APPEAL SUMMARY

<b>Appeal ID:</b> 24408	<b>Project Address:</b> 8120 SE 11th Ave
<b>Hearing Date:</b> 11/25/20	<b>Appellant Name:</b> Edward Radulescu
<b>Case No.:</b> B-013	<b>Appellant Phone:</b> 5036792493
<b>Appeal Type:</b> Building	<b>Plans Examiner/Inspector:</b> Anne Schmidt
<b>Project Type:</b> commercial	<b>Stories:</b> 3 <b>Occupancy:</b> R-2 <b>Construction Type:</b> V-B
<b>Building/Business Name:</b> SE 11th Apartments 2	<b>Fire Sprinklers:</b> Yes - Throughout
<b>Appeal Involves:</b> Erection of a new structure	<b>LUR or Permit Application No.:</b> 20-124269-CO
<b>Plan Submitted Option:</b> mail [File 1] [File 2] [File 3] <b>Proposed use:</b> R-2 Apartments

**11TH AVE**  
**19-UNIT APARTMENT HOUSE**  
**8134 SE 11TH AVE**  
**PORTLAND, OREGON**  
**EPR DESIGN**

**C LEFT SIDE ELEVATION (NORTH)**  
A2.1 SCALE: 1/4" = 1'-0"

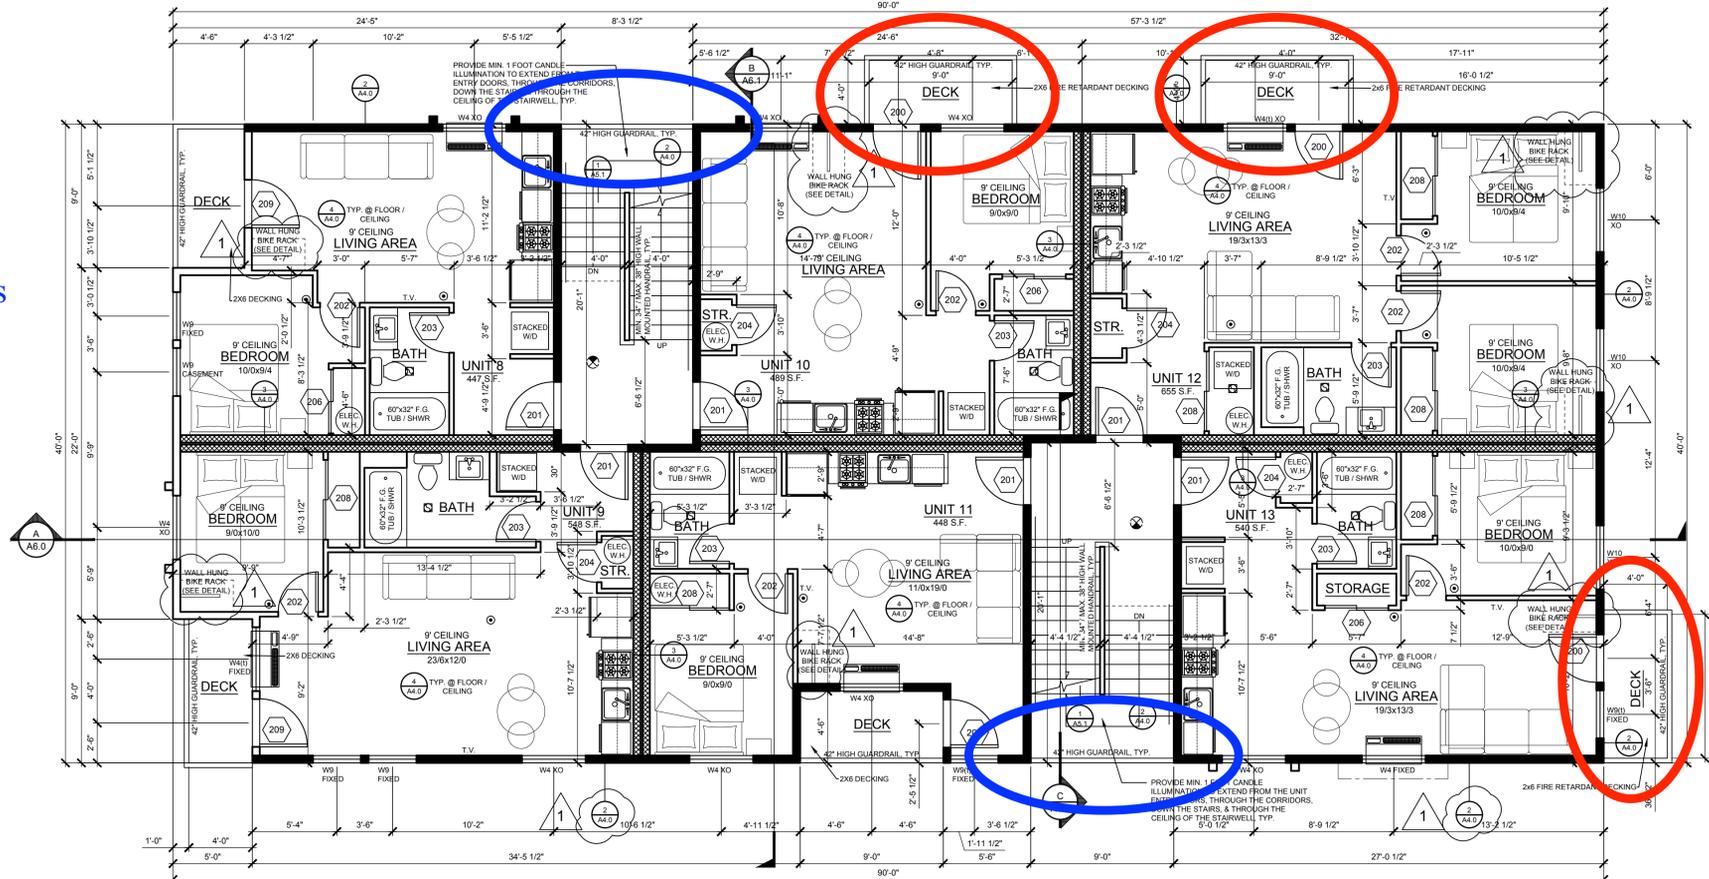
**Appeal item 1**

**Code Section** 705.2

**Requires** Cornices, eave overhangs, exterior balconies and similar projections extending beyond the exterior wall shall conform to the requirements of this section and Section 1406. Exterior egress balconies and exterior exit stairways and ramps shall also comply with Sections 1019 and 1026, respectively. Projections shall not extend any closer to the line used to determine the fire separation distance than shown in Table 705.2.

**Code Modification or Alternate Requested** Applicant wishes to upgrade the sprinkler system to a full NFPA 13, construct the balconies of fire retardant treated wood, and provide sprinkler heads at the balconies in order to allow for a greater projection.

**Proposed Design** This appeal applies to the 4 balconies on the north side of the proposed building - 2 at the 2nd floor and 2 at the 3rd floor. The balconies are stacked. The exterior walls of the building are one hour construction, the balcony guardrails are of non-combustible materials, and the deck will be constructed of fire retardant treated wood and heavy timbers for 1-hour construction. The sprinkler system in the building will be upgraded from NFPA 13R to NFPA 13 and sprinkler heads will be provided at each balcony per the Fire Curtain requirements.

**Reason for alternative** The reason for the alternate is to allow for the units to have an outdoor recreation area that meets the minimum dimensional standards per the zoning code. By constructing the decks as non-combustible materials, installing sprinkler heads, and upgrading the fire sprinkler system to a full NFPA 13 the life safety and fire protection elements are equivalent to that of the code intent.

**Appeal item 2**

**Code Section** 705.8, 1027.5

Openings in exterior walls shall comply with Section 705.8.1 through 705.8.6.2. Table 705.8 allows for openings in a wall with a fire separation distance of 5' to less than 10' and where the openings are unprotected but the building is sprinklered to have 25% openings.

1027.5 requires landings at exterior exit stairs to have a fire separation distance of 10'.

**Code Modification or Alternate Requested** The applicant wishes to not have the opening at the exterior stairs be included in the exterior wall opening area calculation and allow the landings to be at a fire separation distance of 5' from the property line.

**Proposed Design** The exterior stairs are open on 1 side and has a fire separation distance of 5' at the opening and stair landings from the property line. A water curtain will be proposed at the stair landings on each floor and at the ceiling on the 3rd floor per 705.8.2 in lieu of enclosing the stairs and allowing it to be excluded from the fire separation distance opening area calculation. The exterior walls of the building, including the exterior walls that wrap around the stairs are constructed as 1-hour rated exterior wall assemblies. The exception in 705.8.2 states "Opening protectives are not required where the building is equipped with an automatic sprinkler system in accordance to 903.1.1.1 and the exterior openings are protected by a water curtain using automatic sprinklers approved for that use." The applicant wishes to have this exception apply to the exterior wall opening created by the exterior exit stair.

**1. Decrease in maximum allowable fire separation distance of balcony projection: Hold for additional information.**

**2. Increase in allowable area of exterior wall openings with sprinkler protection: Hold for additional information.**
